**Harker Heights
Planning and Zoning
Commission
Meeting & Workshop**

PRELIMINARY PLAT OF: STONE LAKE TRAILS F.M. 2410, Bell County Rural, Texas

**MASTER UTILITY PLAN OF:
STONE LAKE TRAILS**
134.832 ACRES 5,873,300.37 S.F.
117 LOTS, 3 BLOCKS AND 4 TRACTS INCLUDING:
11,157.41 L.F. OF NEW STREETS AND 698,422.79 S.F. OF R.O.W.
JOHN HUGHES SURVEY, ABSTRACT #379, BELL COUNTY TEXAS
A SUBDIVISION IN THE ETJ CITY OF HARKER HEIGHTS, BELL COUNTY TEXAS

Plat Distributed to HH Staff: June 3, 2021

DRAWN BY: RR CHECKED BY: BLB
 SCALE: 1" = 100' APPROVED BY: BLB
 PROJECT FILE: 18005-PP DATE: JUNE 16, 2021

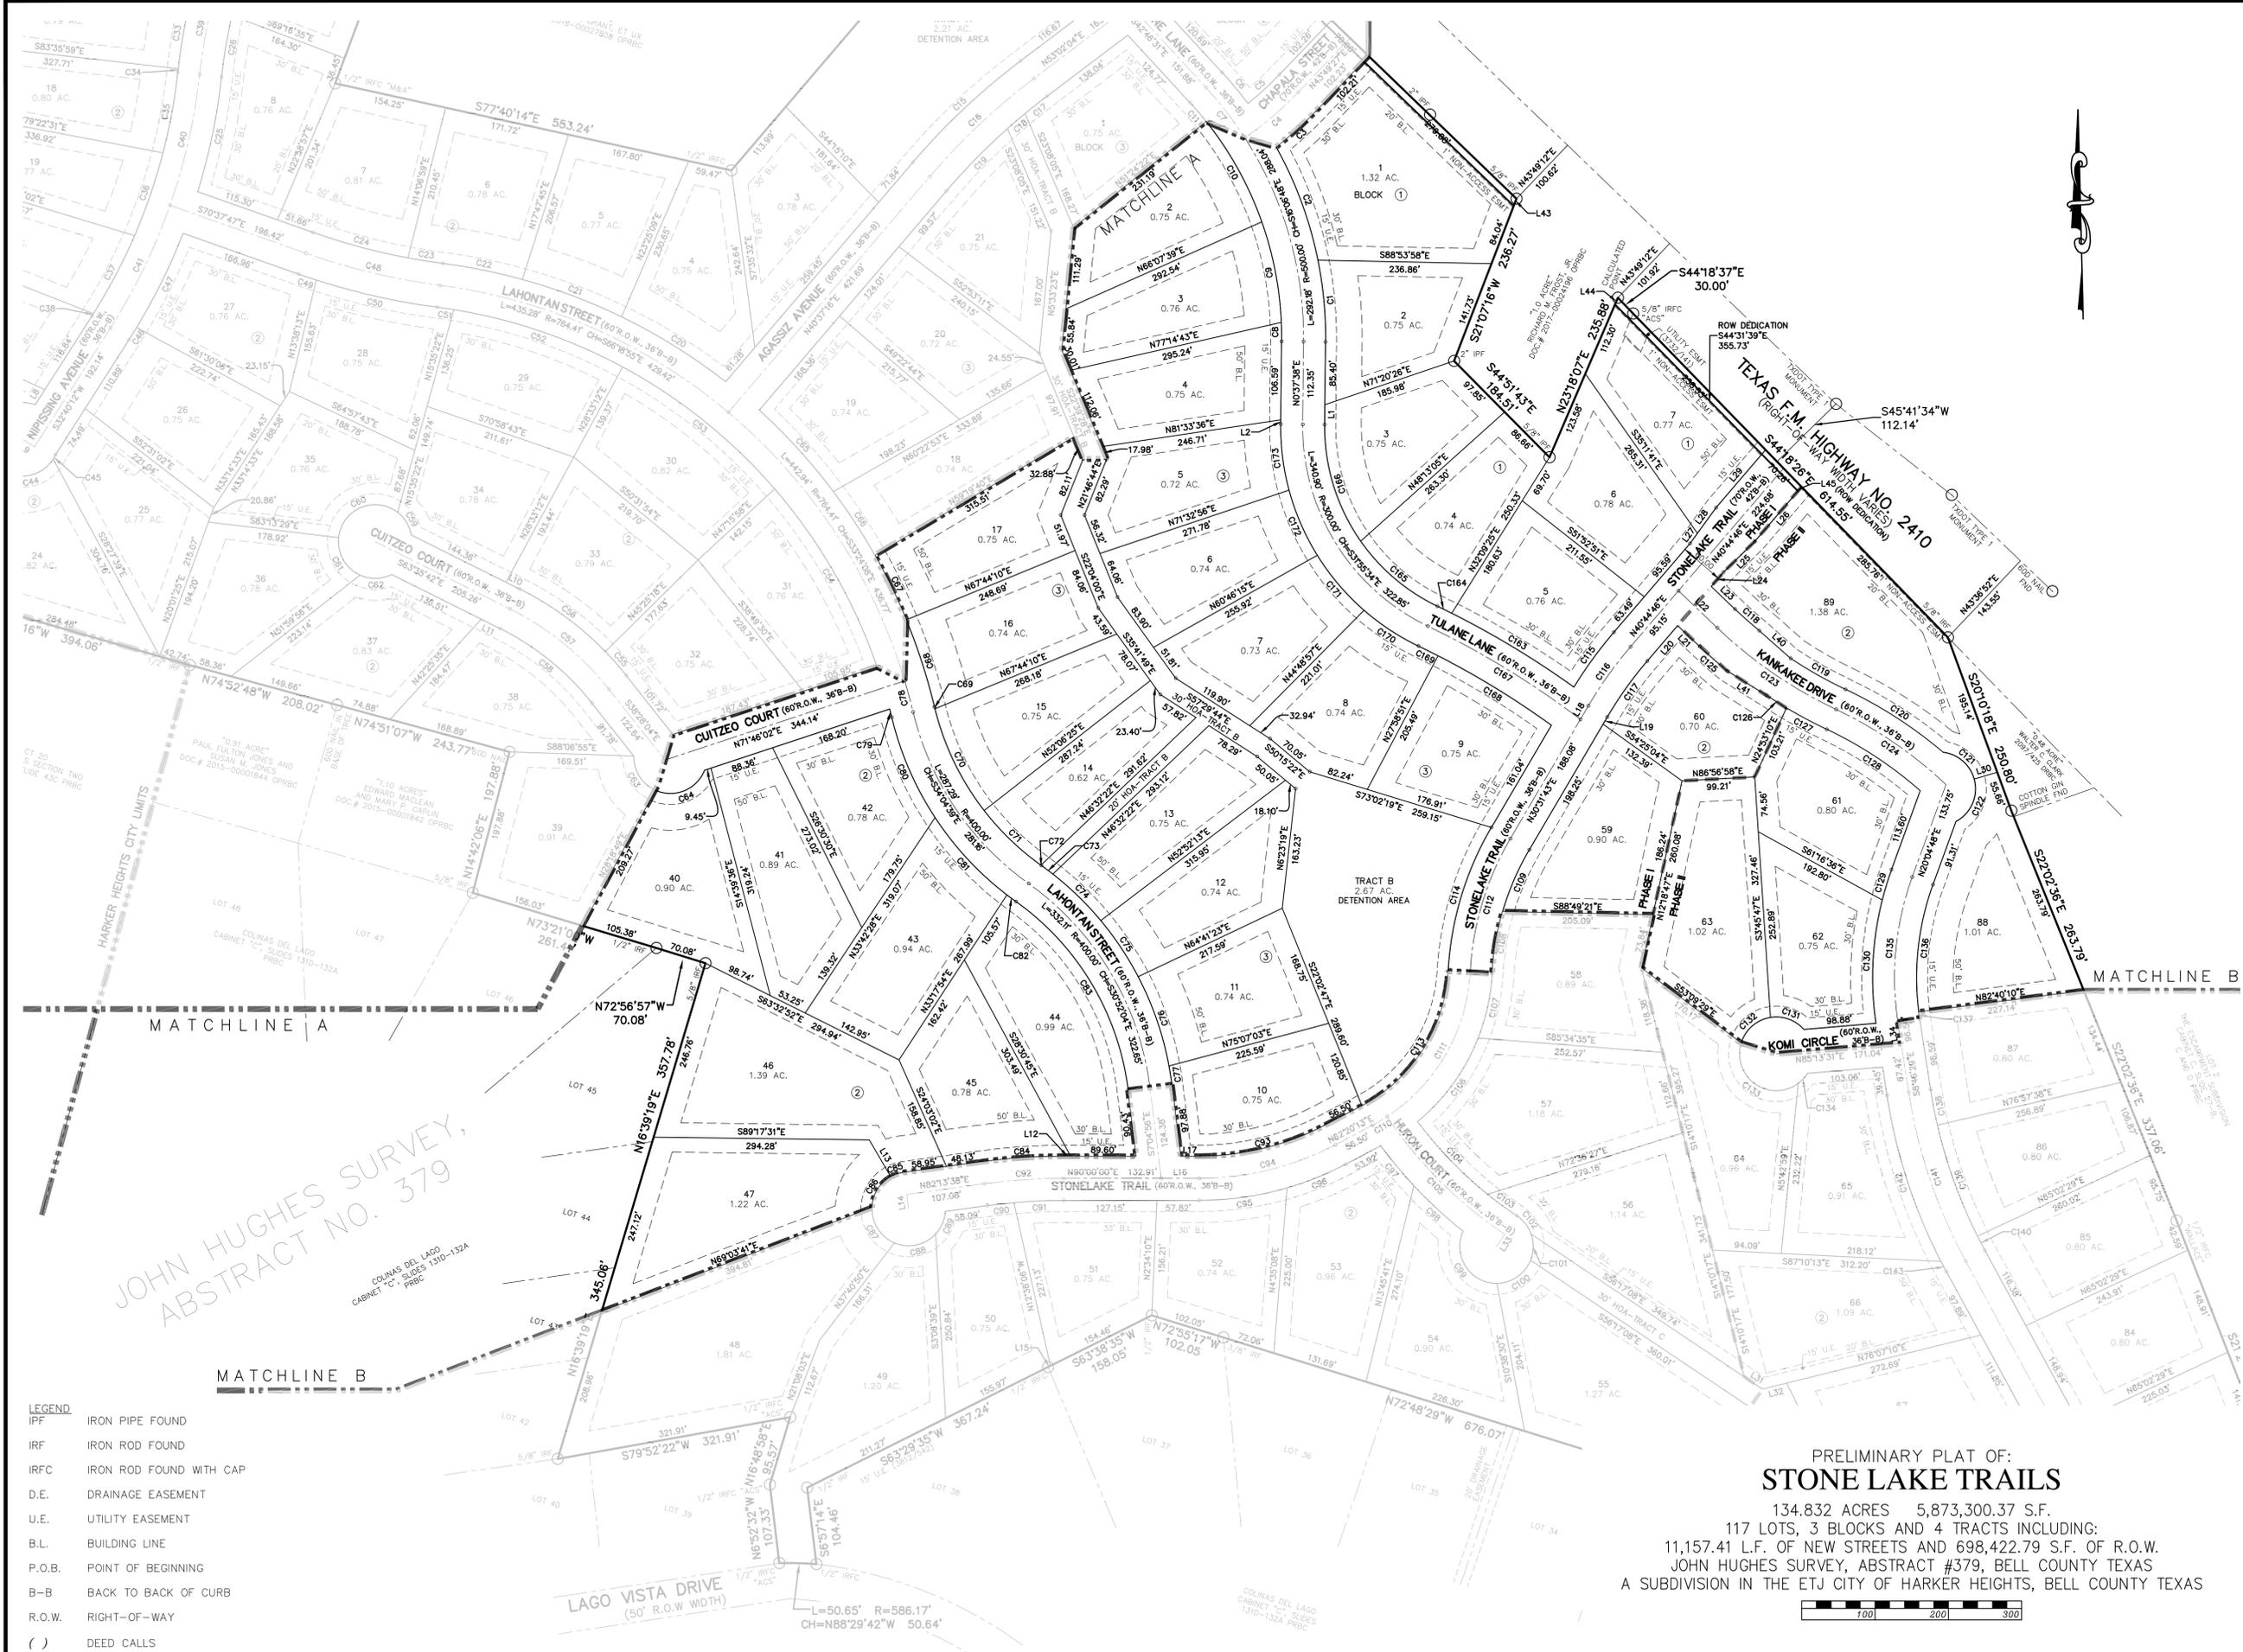
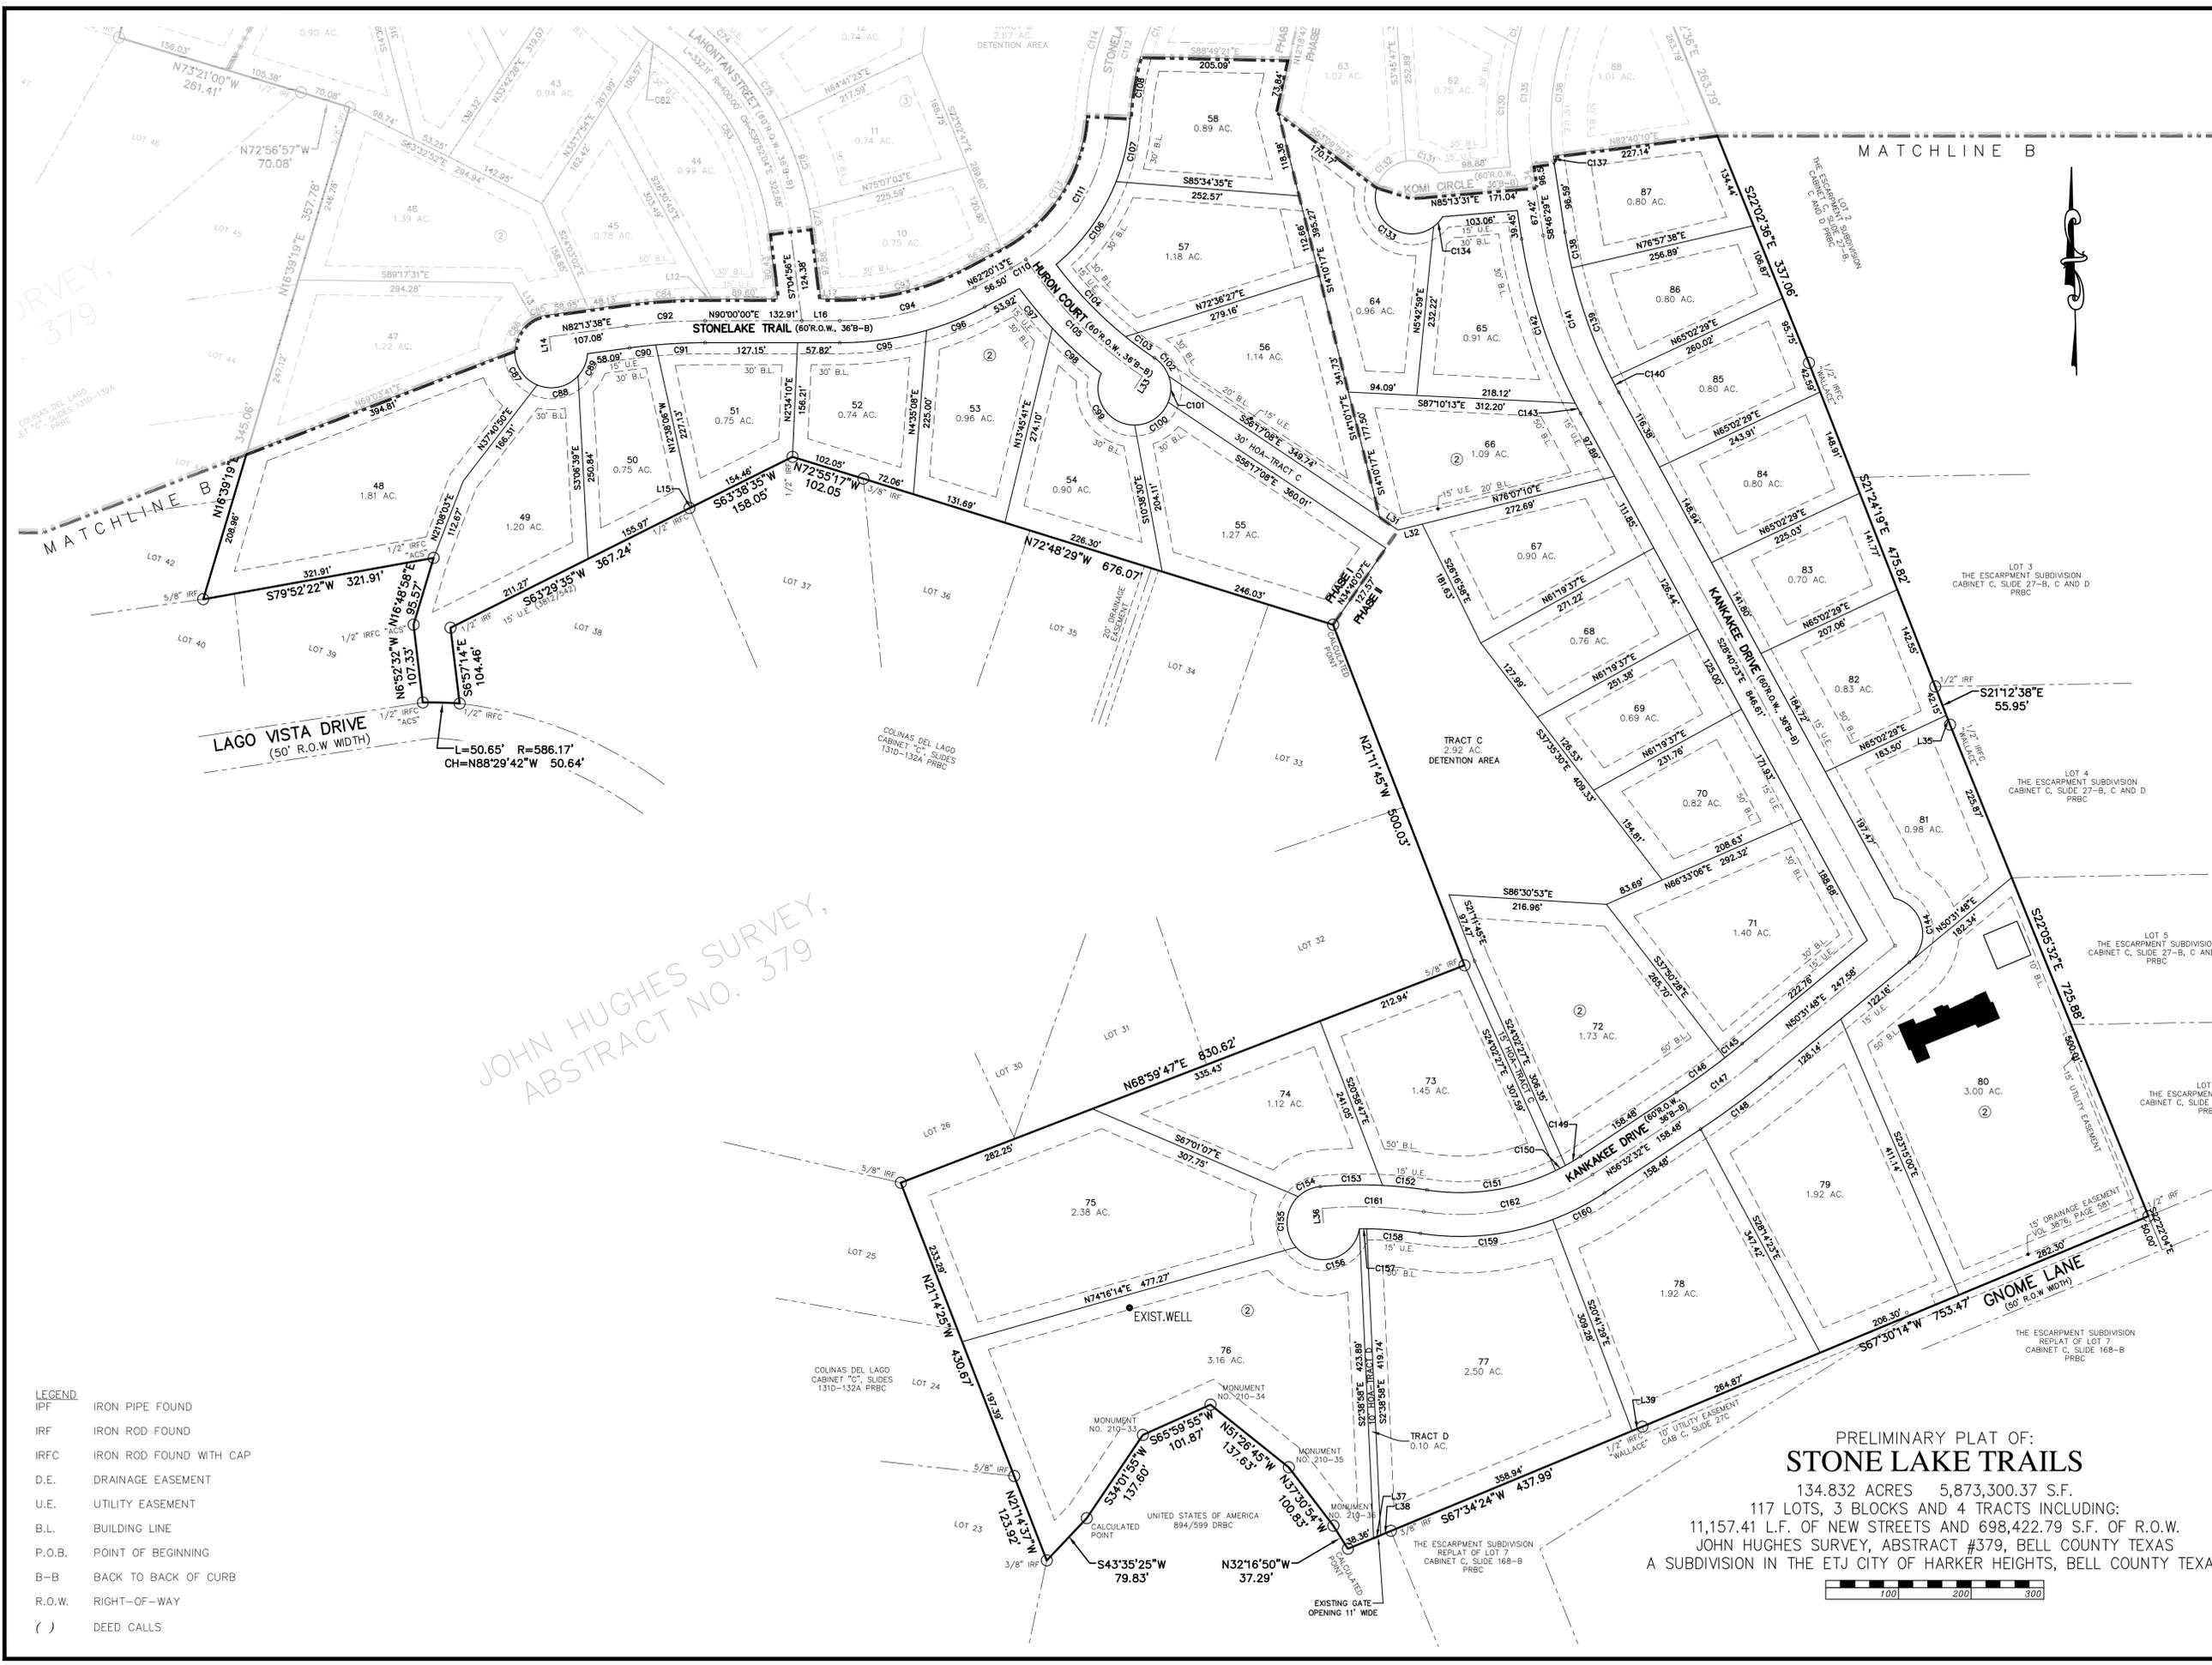
1. Applicant is advised that a concept plan submission is required prior to or with submission of a preliminary plat per §154.20(A)(2)(e).
2. Applicant shall provide a detail with typical building placements and building envelopes.

3. Applicant shall provide half of the lacking right of way to meet the 120' required width along those lots that abut FM 2410 (major arterial).
4. Per §154.37(D)(7), Applicant shall amend the subdivision layout such that the length of Kankakee Drive does not exceed the allowable culdesac length for lots less than 1 acre.

7. Applicant shall clarify the sheet and phase linework such that they are discernable in black & white and when reproduced (different line types).
8. On page 1 of the plat dedication pages, applicant shall provide uniform annotation for all surrounding parcels (lot/block information, subdivision name, type of use for a distance of 300 ft from the plat boundary).

12. Per §154.20(B)(6) applicant shall provide an as-built for the existing property (structures, OSSF, easements). On some of the plan sheets two structures are shown to be located on Lot 80, Block 2. Clarify the intent for those existing structures.

13. Applicant shall clarify the intent for the existing well located on Lot 76, Block 2.

15. Applicant shall provide for utility easements to the adjacent undeveloped parcels.
16. Applicant shall address how the two landlocked parcels south of Lots 36-38 of Block 2 are accessed (connectivity to public ROW).

17. Applicant shall provide for half of the right of way needed to bring the adjacent Gnome Drive into compliance (Lots 77-80 need to dedicate 5' of ROW) & need to illustrate the same for opposite side (Full ROW should be 70'), same for Lago Vista Drive.

18. Provide concurrence from TXDOT showing approval for curb cuts and drainage acceptance.
19. Applicant is advised that all drainage infrastructure shall be completed in Phase 1 of this development or waivers of liability will need to be executed and recorded.

1. Applicant is advised that a concept plan submission is required prior to or with submission of a preliminary plat per §154.20(A)(2)(e). **6/17/21 Not Met. Applicant's response is noted. However, a Concept Plan application was not submitted with the revisions.**

2. Applicant shall provide a detail with typical building placements and building envelopes. **6/17/21 Partially Met. Applicant's response is noted. However, applicant shall amend Surveyor's note #12 such that it is clear that those are the current setbacks at the time of platting and that setbacks are determined by the adopted zoning district as mended by City Council.**

3. Applicant shall provide half of the lacking right of way to meet the 120' required width along those lots that abut FM 2410 (major arterial). **6/17/21 Partially Met. The right of way dedication being offered with this platting action must be reflected on sheet 1 or a note added to refer to Sheets 2-4 for additional detail.**

7. Applicant shall clarify the sheet and phase linework such that they are discernable in black & white and when reproduced (different line types). **6/17/21 Met.**

8. On page 1 of the plat dedication pages, applicant shall provide uniform annotation for all surrounding parcels (lot/block information, subdivision name, type of use for a distance of

300 ft from the plat boundary). **6/17/21 Not Met.** The following clarification is provided per the applicant's request. One Sheet 1 some parcels that are adjacent to this development are labeled by lots and blocks (The Escarpment Subdivision; Lakeside Hills Subdivision), while others are only identified by the subdivision name (Colinas Del Lago). Additionally, code requires that the usage of the lots within 300 feet of the property boundary be identified. If they are all the same use then that can be added in a note on Sheet 1.

9. Applicant shall illustrate the adjacent offsite and onsite existing 20' drainage easement and address connectivity of said easement (Lots 49-56, Block 2, & Tract C). This point discharge shall be taken into account in the drainage analysis. **06/17/21 Partially Met.** The applicant shall illustrate and annotate all drainage easements (yellow) that continue onto this property and ensure that the existing 15' waterline easement by separate instrument (blue highlight) is shown in the proposed subdivision. Applicant shall provide a copy of the water line easement recorded by separate instrument. Applicant shall verify if there are natural swales or low spots in the existing drainage easement and address how the flow will be conveyed from those locations to the proposed Drainage Tract C and not into a proposed home.

1. Applicant is advised that a concept plan submission is required prior to or with submission of a preliminary plat per §154.20(A)(2)(e). **Noted**
2. Applicant shall provide a detail with typical building placements and building envelopes. **Building setbacks have been provided for each lot.**

3. Applicant shall provide half of the lacking right of way to meet the 120' required width along those lots that abut FM 2410 (major arterial). **ROW dedication lines added to get 120' required for FM 2410.**

6. Applicant shall move the drainage tracts dedication from the subdivision block to after the dedication statement and before the applicant's signature. **Drainage tract dedication added after dedication statement and before applicant's signature. These drainage tracts to be owned and maintained by the Home Owners Association.**

7. Applicant shall clarify the sheet and phase linework such that they are discernable in black & white and when reproduced (different line types). **Linework for changed to add variation between phasing lines and sheet lines.**

8. On page 1 of the plat dedication pages, applicant shall provide uniform annotation for all surrounding parcels (lot/block information, subdivision name, type of use for a distance of 300 ft from the plat boundary). **Comment needs clarification.**

11. On all plat dedication pages, the applicant shall identify usage and ownership for all Tracts (A, B, C & D) in a uniform manner (i.e. each have Tract name and acreage with a note for usage and ownership on the dedication page. On Sheet 5 on the plat, a table is given showing the tract name, acreage, ownership and usage.

12. Per §154.20(B)(6) applicant shall provide an as-built for the existing property (structures, OSSF, easements). On some of the plan sheets two structures are shown to be located on Lot 80, Block 2. Clarify the intent for those existing structures. Please see the attached as-builts for the existing structure. Septic permit and information is also included. Existing easements for this structure were added to the plat.

13. Applicant shall clarify the intent for the existing well located on Lot 76, Block 2. The proposed well is to used for landscape irrigation for Lot 76.

15. Applicant shall provide for utility easements to the adjacent undeveloped parcels. Need clarification for this comment. Which parcels are undeveloped and in need of a utility easement.

17. Applicant shall provide for half of the right of way needed to bring the adjacent Gnome Drive into compliance (Lots 77-80 need to dedicate 5' of ROW) & need to illustrate the same for opposite side (Full ROW should be 70'), same for Lago Vista Drive. See variance letter.

18. Provide concurrence from TXDOT showing approval for curb cuts and drainage acceptance. See attached email showing TxDOT approval of curb cuts. Drainage acceptance to be closer to final plat.
